Access Compliance Report Public Rights-of-Way (Curb Ramps)

Intersection ID: 52148 Main Street: OLD ARDREY KELL RD Cross Street: ARDREY PLACE DR Location: SW **Overall Compliance: No Severity Score:** 22.5 ADA ID: 9E1FA9D5C3AF Ramp Type: Combination1 Initial Pass/Fail: Fail

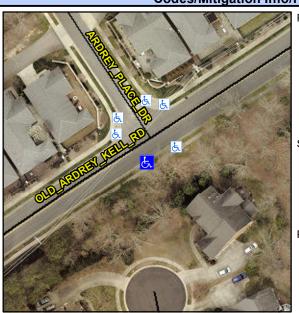
Street 1 Name None Stop Condition-Street 1 OLD ARDREY KELL RD Street 2 Name N/A Stop Condition-Street 2 N/A Possible Solutions: Compliance Description N/A Remove & Replace Entire Ramp. No No Yes N/A Yes Surveyor Notes: N/A RT RP < 5% N/A N/A N/A N/A PROW/ADA: N/A Not Found, R304.5.1, R304.2.2, N/A R304.5.3, R304.3.2 N/A N/A N/A
